# ADDENDUM NO. 3

**August 19, 2022**

## **Additions and Renovations Hawthorne Elementary School**

ADDENDUM NO: 3

**DRAWING NUMBER**  
E103

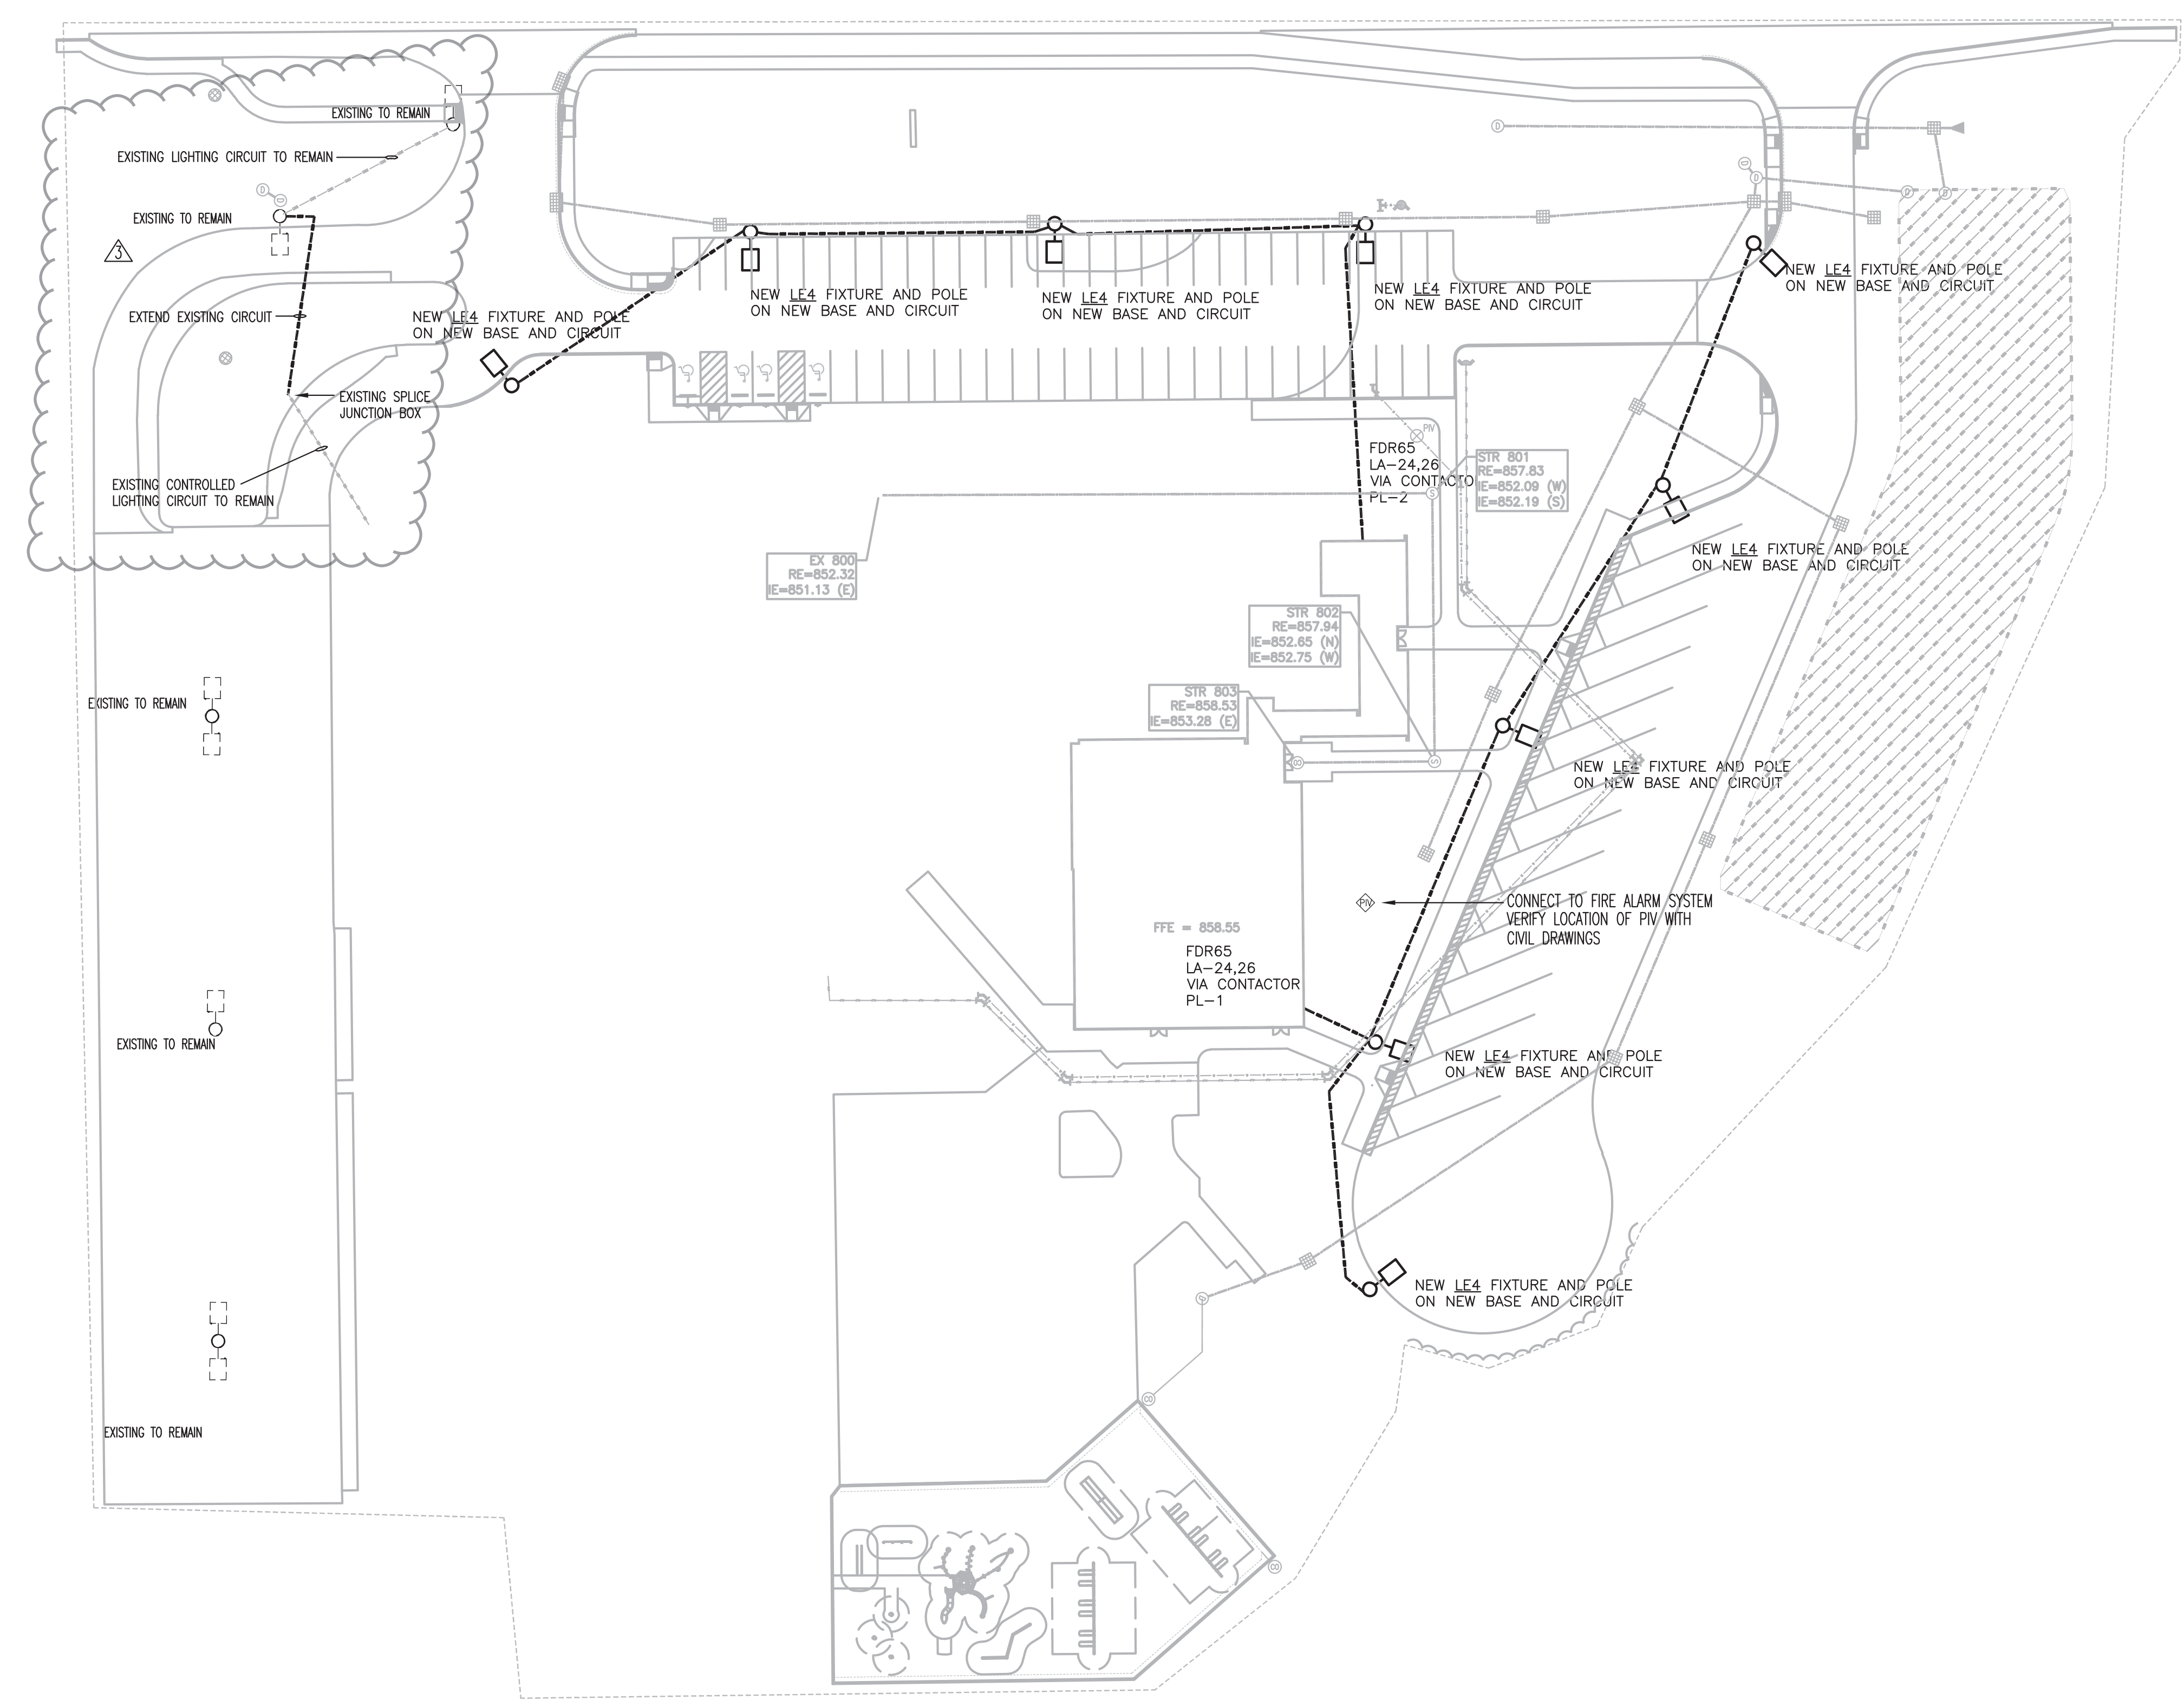
Item 2. Sheet E103 Electrical Site Plan  
Replace with attached drawing.
